#### **Department of Energy**

Enclosed please find a minor modification to the final Building 776/777 Decommissioning Operations Plan (DOP) This minor modification is being submitted in accordance with Section 4 5 2 of the DOP and Paragraph 127 of the Rocky Flats Cleanup Agreement (RFCA) The modification includes Resource Conservation and Recovery Act (RCRA) unit-specific closure information for RCRA units located in Sets 7, 11, 26 and 61

Building 776/777, SET 7 Tanks 1103, 1104, 1106 (RCRA Units 95.006, 95.007, 95.008) Modification #3

Modification #3

Building 776/777, SET 11 Pencil Tank T-7 RCRA Unit 95.014

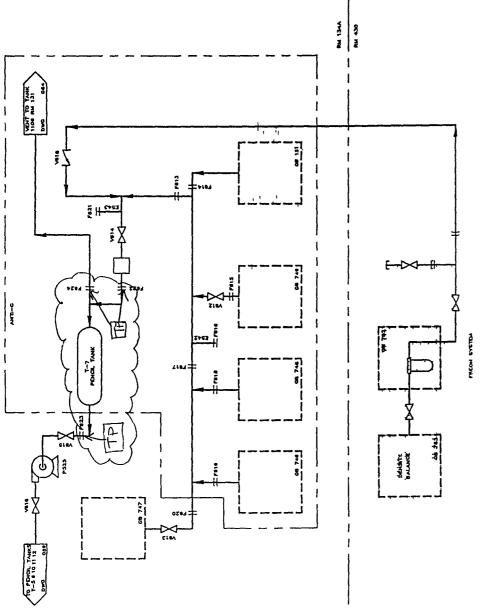
SET#	RCRA Unit #(s)	<b>Description</b>	Regulatory Status	Closure Seaus.				
11	95.014	Pencil Tank T-7	Mixed Residue	RCRA Stable/Physically Empty				
Unit Desc	ription.	Pencil Tank T-7 is located in Room 134E in Building 777 T-7 was used as a surge tank, which collected waste oils, coolants, and carbon tetrachloride from machining processes located in the gloveboxes in Room 134E, and freon from the density balance located in Glovebox 763 in Room 430 From T-7, the waste was transferred to a series of five pencil tanks (T-5, T-6, T-10, T-11, and T-12) in Room 134 The waste from the five pencil tanks was then transferred to Tank 1104 in Room 131 (SET 7) Tank T-7 is vented to Tank 1106 in Room 131						
		T-7 was drained and isolated in 1997, when the five pencil tanks were closed as part of Mixed Residue Pencil Tank Closure Project #2						
Unit Bour Interfaces	ndaries and	RCRA Unit 95 014 includes Tank T-7 and associated ancillary equipment in Room 134E. The attached drawing shows a schematic of the tank and ancillary equipment. This closure activity is limited to the removal of T-7, only. The associated ancillary piping will be removed with Gloveboxes 746, 747, 748, 749 and associated M-lines, and mixed residue vacuum accumulators V-746, V-747, V-748, and V-749, at a later time

EPA Was	te Codes:	D006, D007, D008, D019, F001, F002						
Selected (Option:	Closure	Unit removal without onsite treatment						
Closure Requirem	ents:	The work effort will include disconnecting the tank from the vent line and the inlet and outlet piping, installing blank flanges on the lines remaining, size-reducing the tank (if necessary), and packaging the tank for offsite disposal						
Waste Dis	sposal:	mixed waste Upon the waste acceptance waste cannot be ship	is are present, they will be absorbed. The tank will be disposed of as pon final radiological characterization, the tank will be packaged to meet ance criteria (WAC) of the approved disposal facility. In the event this shipped directly to the approved disposal facility, it will be stored in an storage area until shipment can be scheduled.

Building 776/777, SET 26 Holding Tank T-2 RCRA Unit 95.016

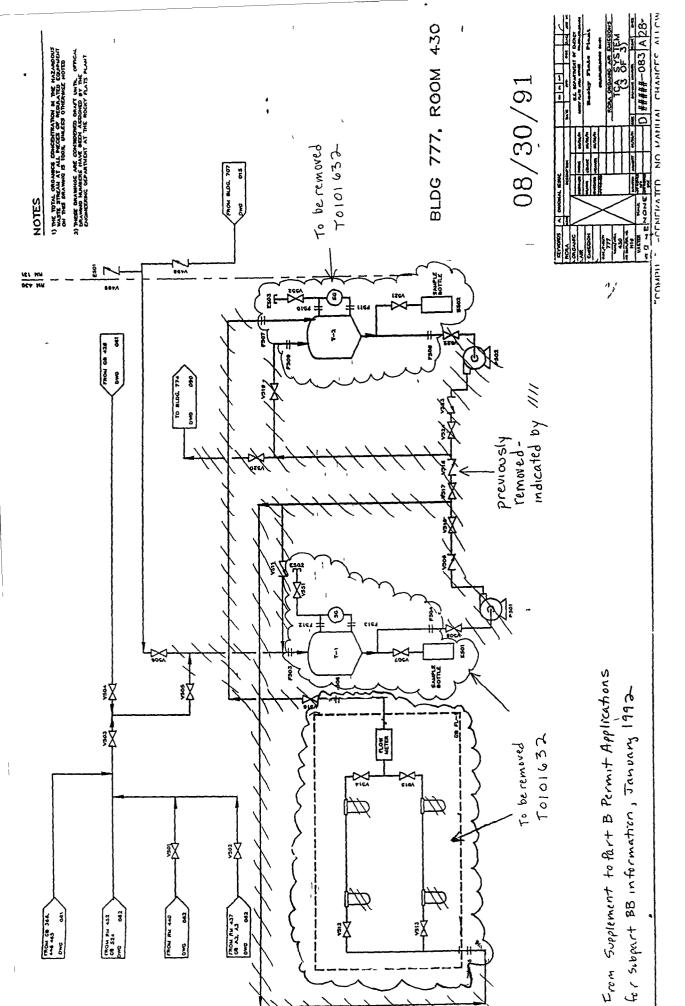
SET #	RCRA Unit #(s)	Description	Regulatory Status	Closure Status			
26	95.015 95.016	Holding Tank T-1 Holding Tank T-2	Mixed Residue Mixed Residue	Physically Empty Physically Empty			
Unit Desc	eription.	steel, raschig-ring tanks 150 gallons and 170 gal were used to collect wa gloveboxes in Building Building 707 The was Glovebox FL-1, and tra to an overhead line, who	s were built in 1969, and had ap illons respectively (subtracting t ste 1,1,1-trichloroethane (TCA) 777 (Rooms 430, 437, 440, and te TCA from both buildings wa nsferred to Tank T-2 From Tan	d 452), and from Tank V-100 in is collected in Tank T-1, filtered in ink T-2, the waste TCA was pumped I line, which was used to transfer oil			
		The raschig rings were removed from both tanks in January 2000 No residual liquid or sludge was present. The ancillary pumps, filters in Glovebox FL-1, and the inlet piping back to the first valves above the tanks were also drained and removed at that time The outlet piping from Tank T-2 to the tie-in with the waste oil/coolant piping was drained and removed in July 1998 The remaining ancillary inlet piping that connected Tanks T-1 and T-2 to waste sources in Building 777 (Rooms 430, 437, 440, and 452), and to Tank V-100 in Building 707, has not been drained.

Unit Boui Interfaces	idaries and	RCRA Units 95 015 and 95 016 consist of Holding Tanks T-1 and T-2 and associated ancillary equipment, including Glovebox FL-1, piping located inside Glovebox FL-1, and the remaining inlet piping that connected Tanks T-1 and T-2 to waste sources in Buildings 777 and 707 The attached drawings show Tanks T-1 and T-2, and a schematic of the tanks and ancillary equipment.					
EPA Was	te Codes:	F001, F002					
Selected C	Closure	Tanks and ancillary pipi	ing Unit removal without onsit	e treatment.			
Option.		Glovebox FL-1 Unit removal in conjunction with "debris rule" treatment (i e, either water washing/spraying or liquid phase solvent)					
Closure Requirem	ents:	This closure activity includes (1) removal, size reduction (if necessary), and packaging of Tanks T-1 and T-2, the vent line connecting each tank to Glovebox FL-1, and the ancillary piping inside Glovebox FL-1, and (2) "debris rule" treatment, removal, size reduction (if necessary), and packaging of Glovebox FL-1

The remainder of the ancillary inlet piping that connected Tanks T-1 and T-2 to waste sources in Building 777 and 707 will be removed during the decommissioning of SET 29 (piping in Room 437), SET 27 (piping in Room 440), SET 35 (piping in Room 452), and SET 78 (miscellaneous piping over eight feet)					
Waste Dis	posal.	The tanks will be disposed of as mixed waste If, after "debris rule" treatment, Glovebox FL-1 meets the standard for a "clean debris surface," and it does not exhibit a hazardous waste characteristic, it will be disposed of as solid waste. If not, it will be disposed of as mixed waste.					
		Upon final radiological characterization, the tanks will be packaged to meet the waste acceptance criteria (WAC) of the approved disposal facility. In the event this waste cannot be shipped directly to the approved disposal facility, it will be stored in an approved onsite storage area until shipment can be scheduled.

Building 776/777, SET 61
Pilot Fluidized Bed Incineration System
Pencil Tanks T-1 and T-2
RCRA Unit 49.02

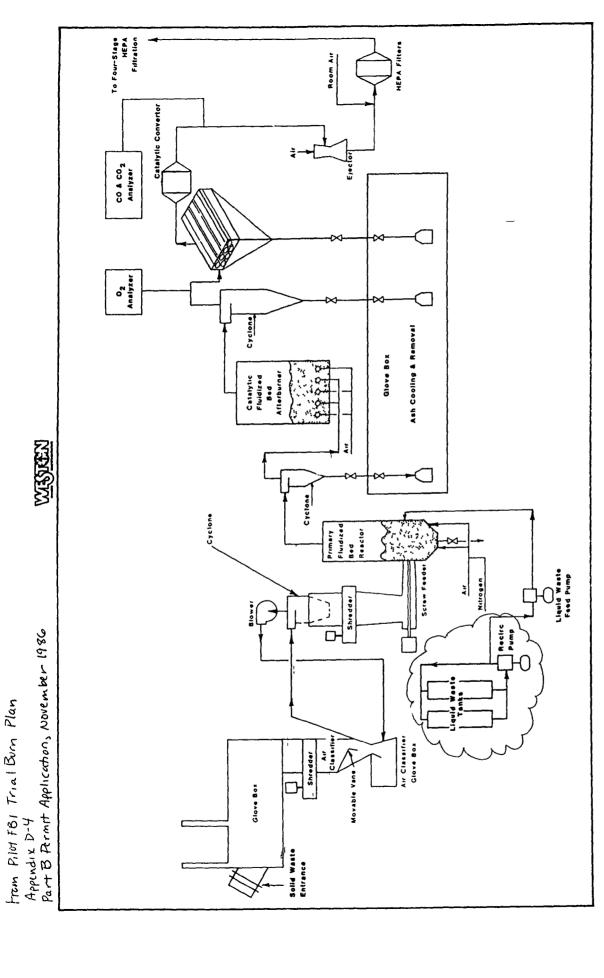
Unit Description:	Pencil Tanks T-1 and T-2 in Room 134 were used as feed tanks for the Pilot Fluidized Bed Incinerator (FBI) They are six-inch diameter stainless steel tanks, with capacities of approximately eight gallons each. Liquid wastes were received in 55-gallon drums and pumped through a filter into the pencil tanks. The liquid was mixed by pumping it through a recirculation loop with a Sandpiper double diaphragm pump. A variable displacement metering pump was used to deliver the liquid waste to the primary reactor in the incinerator chamber.  Pencil Tanks T-1 and T-2 have contained various organic solvents, degreasing fluids, lubricating oils, cutting oils, and other oil/solvent wastes from laboratories and production areas at Rocky Flats. Methanol was used during start-up to bring the incinerator up to operating temperature. An EPA-approved trial burn for PCBs was conducted in the pilot FBI in May 1981 using a feed comprised of 25 weight percent pyranol A13B3B3 (PCB transformer fluid) and 75 weight percent kerosene (Conoco LPA solvent). The test burn

achieved a 99 9999 percent destruction efficiency
	The tanks were drained in May 1996 and the tank piping was locked/tagged out
Unit Boundaries and Interfaces:	RCRA Unit 49 02 includes the FBI Pilot Unit, Pencil Tanks T-1 and T-2, and associated ancillary equipment. The pencil tanks, Sandpiper pump, two filters, and some ancillary piping are located in Room 134 Additional filters and the metering pump are located in Room 135 outside the incinerator canyon, and the pilot FBI unit and feed lines are located inside the incinerator canyon. The attached drawings show a schematic of the entire system and a schematic of the tanks and ancillary equipment.
	This closure activity includes removal of the pencil tanks, Sandpiper pump, filters, and ancillary piping in Room 134 only. The piping will be capped at the wall between rooms 134 and 135. The FBI Pilot Unit will be removed at a later date.
EPA Waste Codes:	D001, F001, F003, F005, and U044

Selected Closure Option	Unit removal without onsite treatment
Closure Requirements.	The work effort will include disconnecting electrical, air, and nitrogen lines, tapping low points in the system and draining residual liquids (if necessary), draining and removing the filters, and removing the ancillary piping and pump. The tanks will then be removed, size-reduced in place or moved to a central size reduction facility, and packaged for offsite shipment.
Waste Disposal·	If residual liquids are present, they will be drained or absorbed. The tanks will be disposed as mixed waste. Upon final radiological characterization, the tanks will be packaged to meet the waste acceptance criteria (WAC) of the approved disposal facility. Hoisting and rigging equipment will be used to facilitate transport to a size reduction facility, if necessary. In the event this waste cannot be shipped directly to the approved disposal facility, it will be stored in an approved onsite storage area until shipment can be scheduled.
